MARCH 25, 2024

ADDENDUM NO. 1

TO CONSTRUCT **BIRKHIMER EMERGENCY OPERATIONS CENTER (EOC)
UPGRADES AND IMPROVEMENTS
PROJECT NO.: CA-202313-C
TAX MAP KEY: 3-1-042:600
Honolulu, Oahu, HAWAII**

A1
EB102

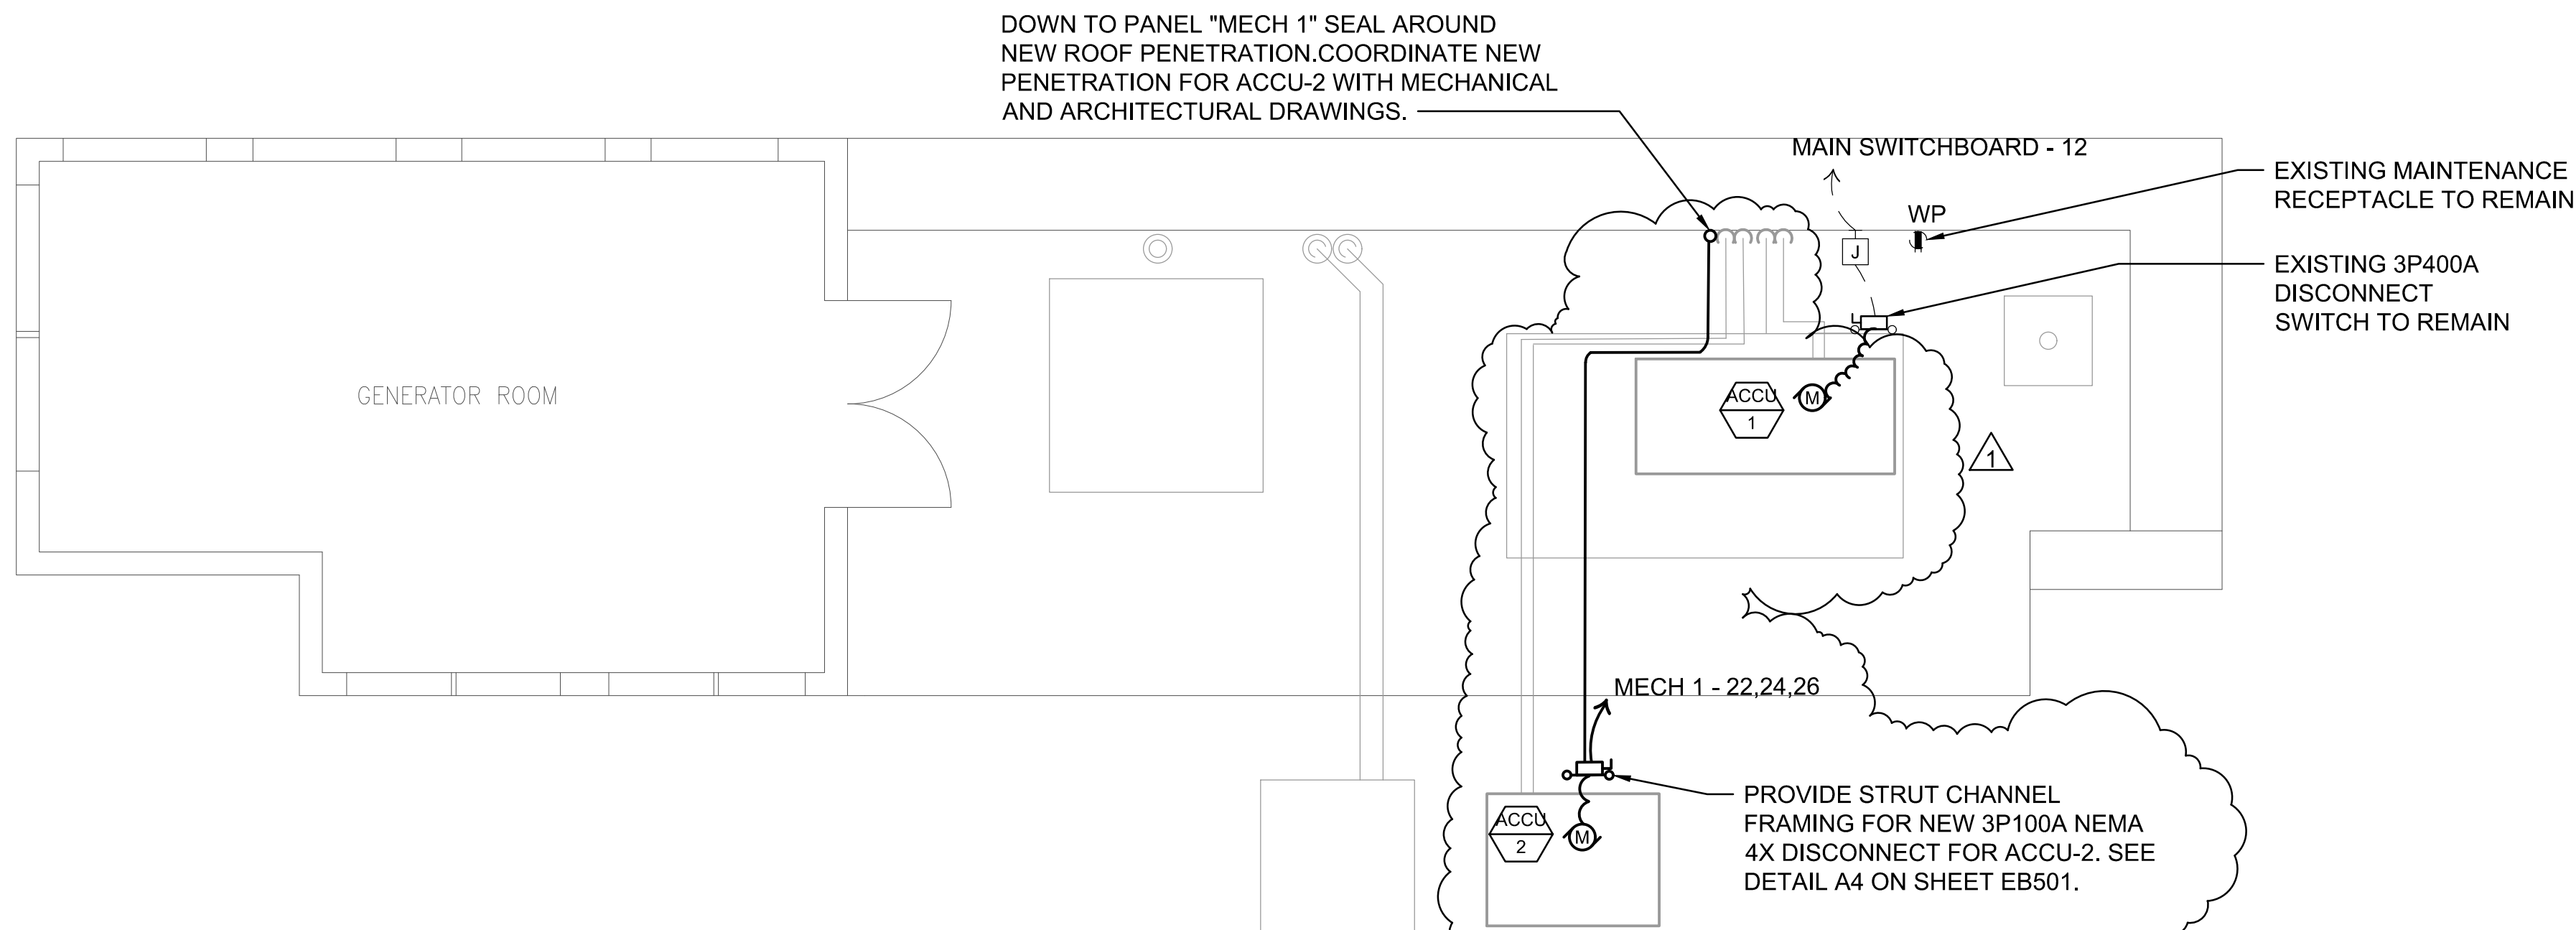
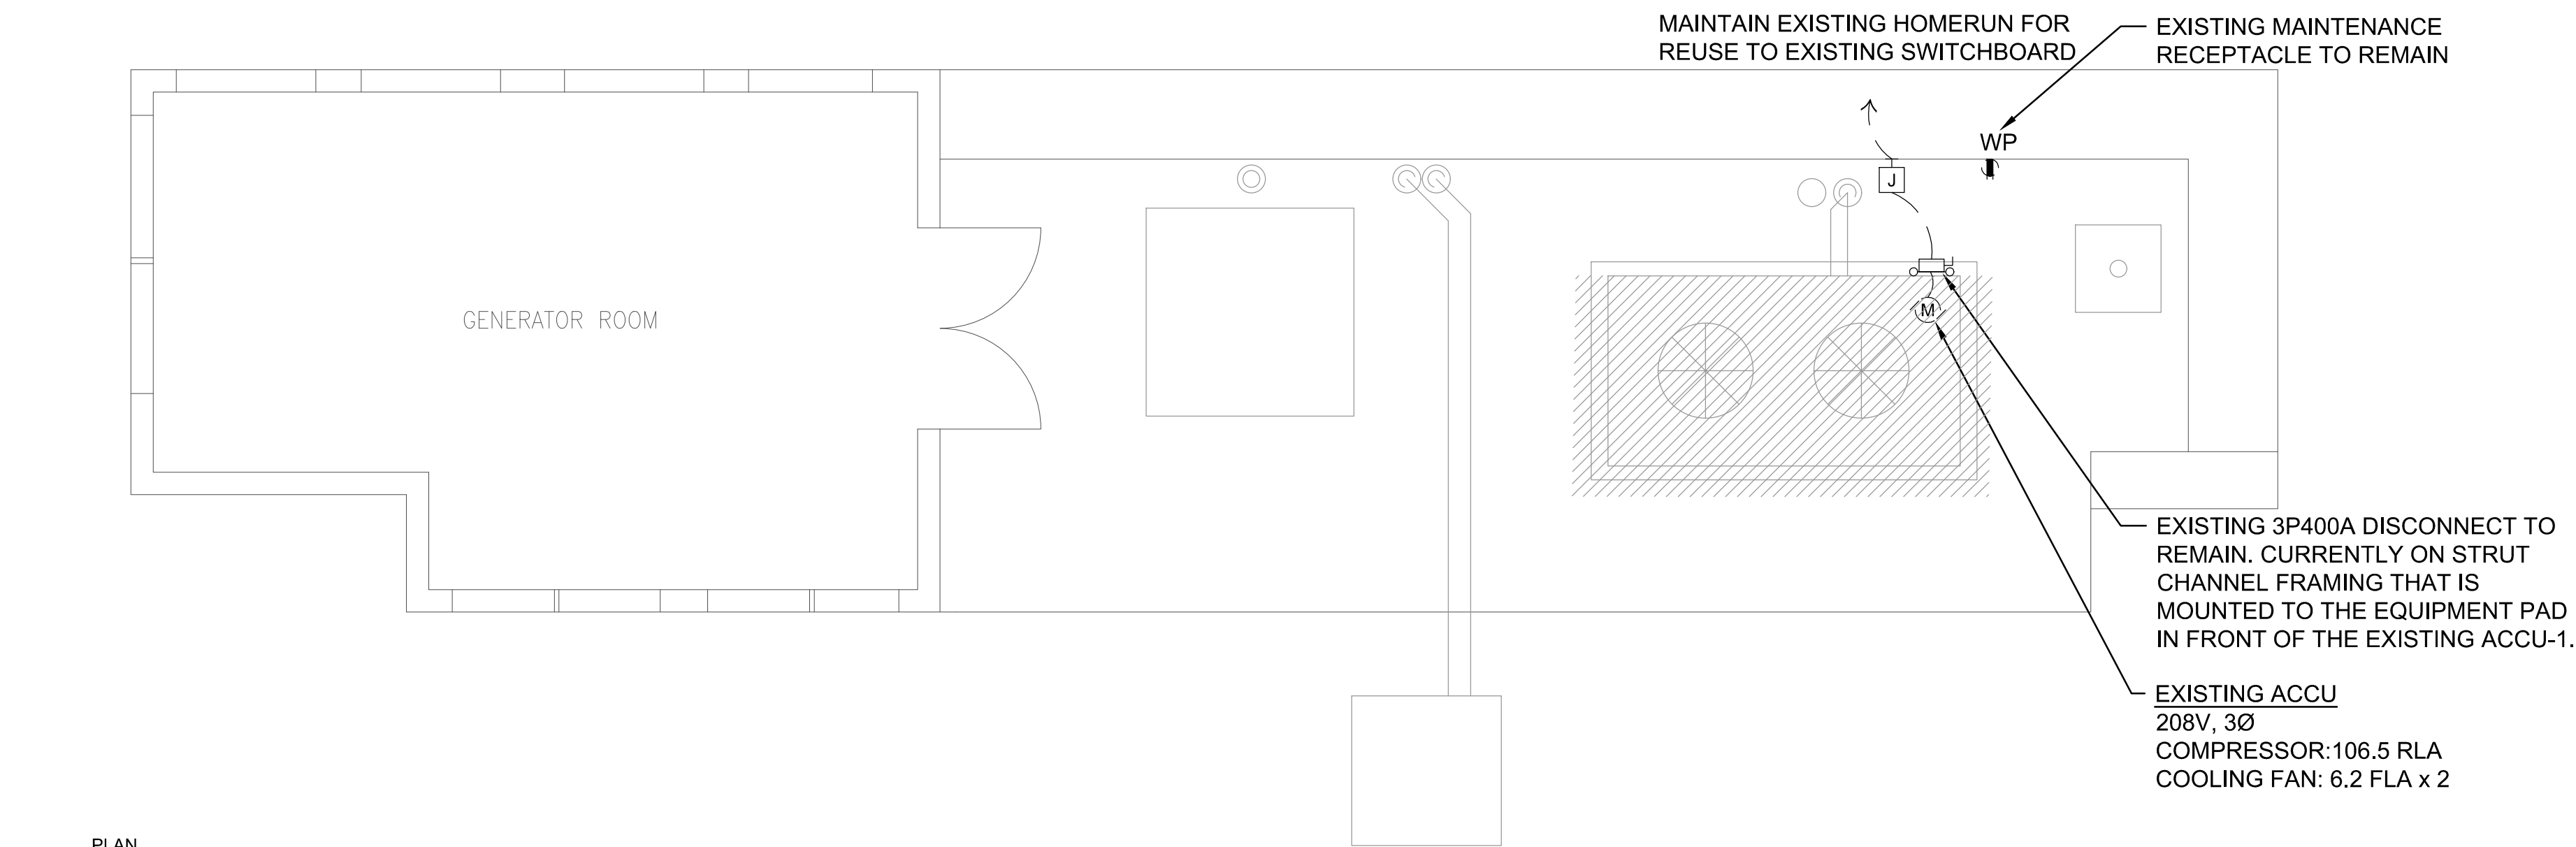
ELECTRICAL	EB102	Revised location of ACCU-2 and orientation of ACCU-1 due to structural concerns.
ELECTRICAL	EB201	Revised circuiting for the light fixtures, lighting controls and receptacle Added New Work Note #1: "Intercept existing circuit via a junction box and extend to room controller and new lights."
ELECTRICAL	EB202	Added keynote #2 to "EXISTING PUMP CONTROL PANEL" callout. Hatched out the existing pump control panel.
ELECTRICAL	EB203	Added 120V power for smart water meter Added Duct Section #2 (1"C comm with pull string) for smart water meter that leads to a junction box located in the storage room. Added (2) handholes.
ELECTRICAL	EB204	Added 120V power for the fuel supply pump that will be mounted on and used for the temporary tank. Added (1) handhole. Added new "MECH 2" panel to the sheet Added phasing note P1: "NEW PANELS "MECH 1" AND "MECH 2" TO BE INSTALLED PRIOR TO THE INSTALLATION OF TEMPORARY TANK MOUNTED FUEL SUPPLY PUMP AND OTHER PLUMBING EQUIPMENT. PROVIDE 120V POWER AND SUPPORTING CONDUCTORS VIA NEW "MECH 2" PANEL, TO (1) TANK MOUNTED FUEL SUPPLY PUMP. REMOVE TEMPORARY BRANCH CIRCUITING, DISCONNECT SWITCHES, AND EQUIPMENT CONNECTIONS WHEN THE TEMPORARY TANK IS REMOVED."
